REMARKS

Application No.: 09/613,940

Filed: July 11, 2000

FIG. 16c

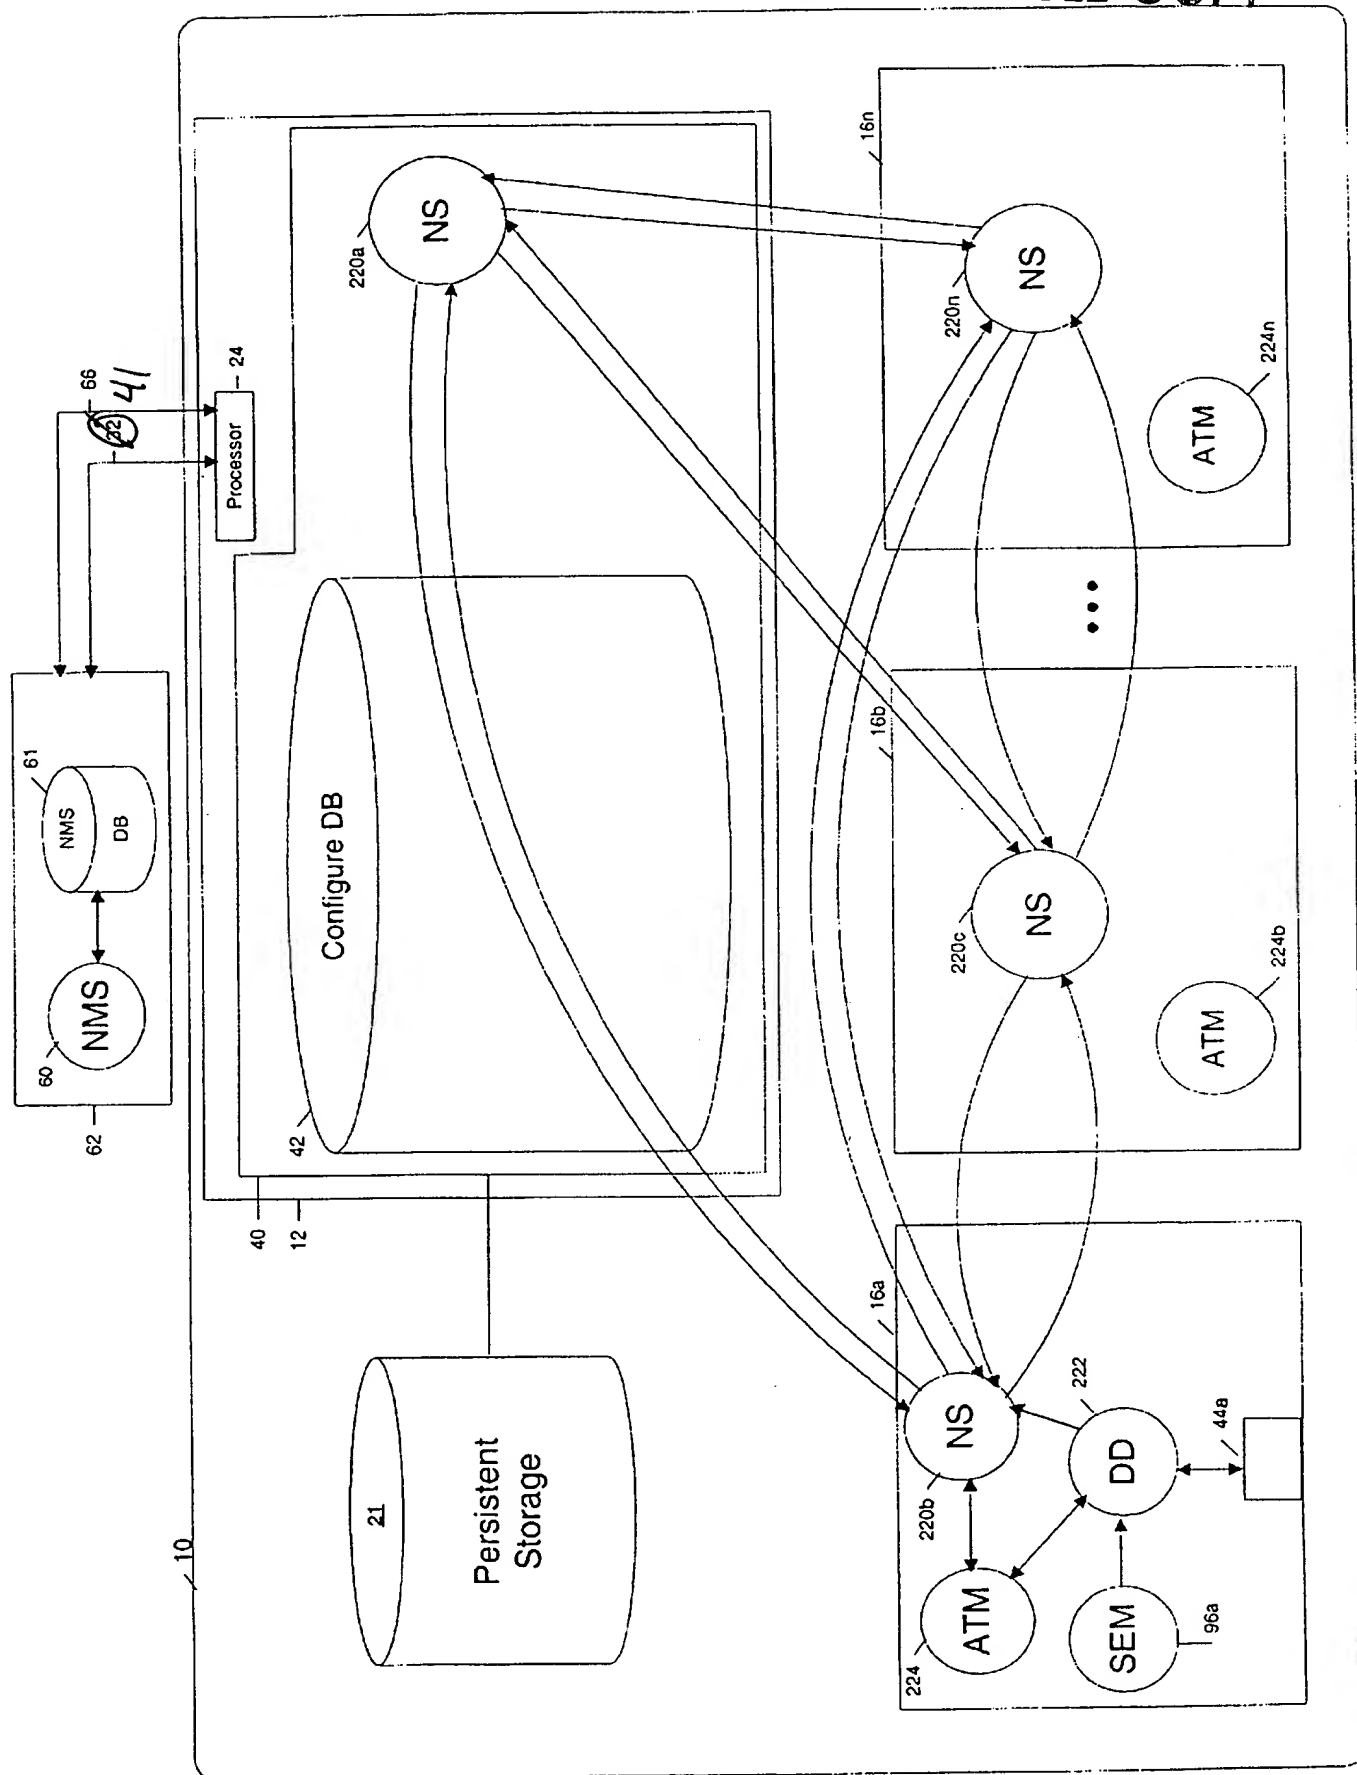
Please amend Figures 9, 16c, 17, 18, 19, 20, 23, 26, 35, and 55 as shown in red in the attached drawings.

Applicant amends the specification and Figures 9, 16c, 17, 18, 19, 20, 23, 26, 35, and 55 to correct typographical errors. Specifically, reference numeral 32 is a duplicate. Therefore applicant replaces reference numeral 32 with reference numeral 41 in both the specification and Figures 9, 16c, 17, 18, 19, 20, 23, and 26. Applicant adds reference numeral 41 to the connection between NMS 60 and the network device 540 in Figure 35. Reference numeral 838 is added to the input marked "Alt. Input from other EX CTS" in Figure 55. Both reference numeral 41 and reference numeral 838 are referred to in the specification and used in other figures to designate the same part of the invention. No new matter is added by these amendments.

FIG. 55

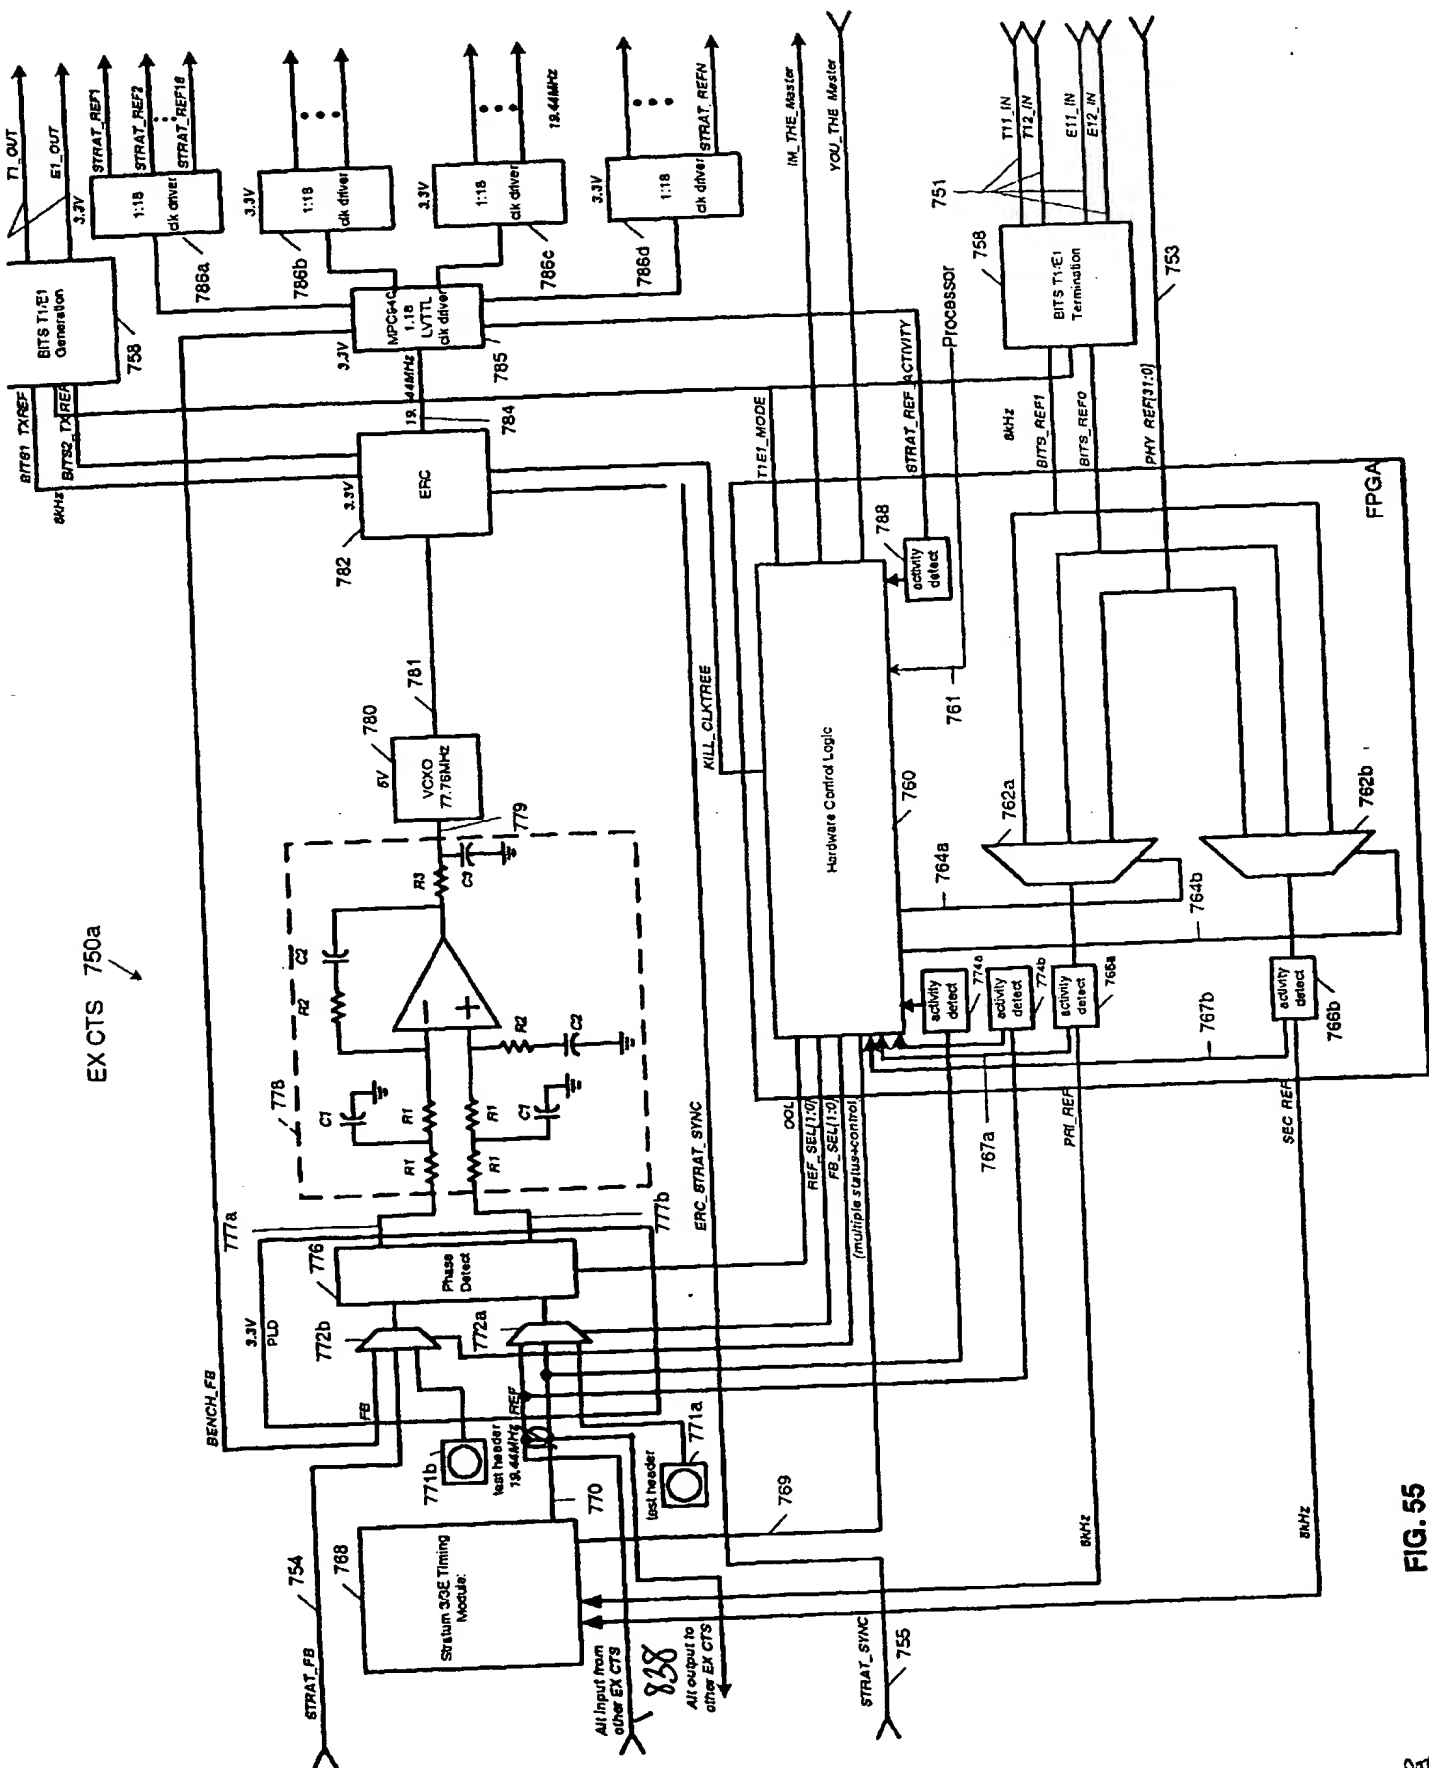
In addition, Applicant amends Figure 55 to remove an extraneous line section to indicate the correct connection of the *output 770* to the *Alt. output* to other EX CTS. Support for this amendment can be found throughout the specification, for example, on page 129, lines 15-17. In particular, the specification at page 129 recites that "the output 770 (marked "Alt. Output to other EX CTS") of timing module 76 may be provided to the other EX CTS and received as input 838 (marked "Alt. Input from other EX CTS"). Thus, no new matter is added by this amendment.
